Joseph M. Farley Nuclear Plant Units 1 and 2
Docket Nos. 50-348 and 50-364

Subject: Response to Request for Additional Information Regarding Emergency License
Amendment Request: Technical Specification 3.6.5, Containment Air Temperature,
One-Time Temporary Change to Limit

SNC Response to NRC RAIs SNSB - RAI 1 through SNSB - RAI 4

FNP Unit 1 and Unit 2 Service Water Temperature Graph

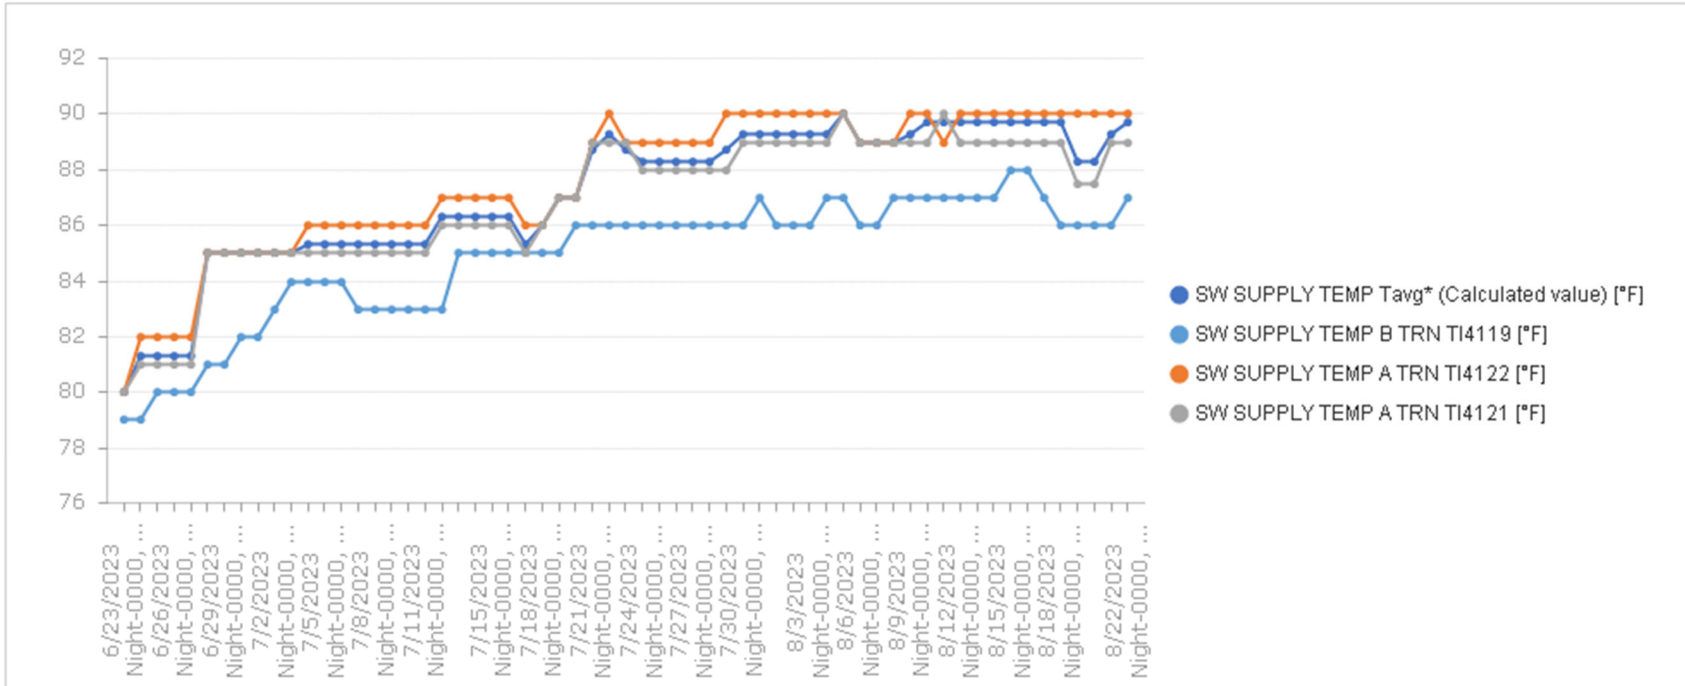
Table 6.2-3 of the FSAR for Farley Units 1 and 2 states the Service Water (SW) temperature at 95°F as the initial condition for the analysis. In section 3, sub-section '*Service Water and Ultimate Heat Sink Evaluation*' of the LAR, the licensee states that the small increase in containment temperature at the start of the event represents an insignificant effect compared to the magnitude of decay heat from both units. However, there is no discussion present on how the SW temperature change due to higher outside temperatures will impact the Containment Air Temperature limit value. Please provide historical data for the SW temperature and any potential adverse impact on the Containment Air Temperature limit due to higher outside temperatures.

Refer to the Attachment for recent Unit 1 and Unit 2 Service Water Temperature graphs.

While the ultimate heat sink (UHS) (i.e., the source for SW) temperature might be expected to rise in conjunction with the projected increased ambient temperatures, FNP does not anticipate the ultimate heat sink to exceed its Technical Specification limit of 95°F (Surveillance Requirement 3.7.9.2), which is consistent with analysis assumptions. As such, there will be no adverse impact as a result of an increase in SW temperatures within the TS limits on the evaluations provided in the requested amendment.
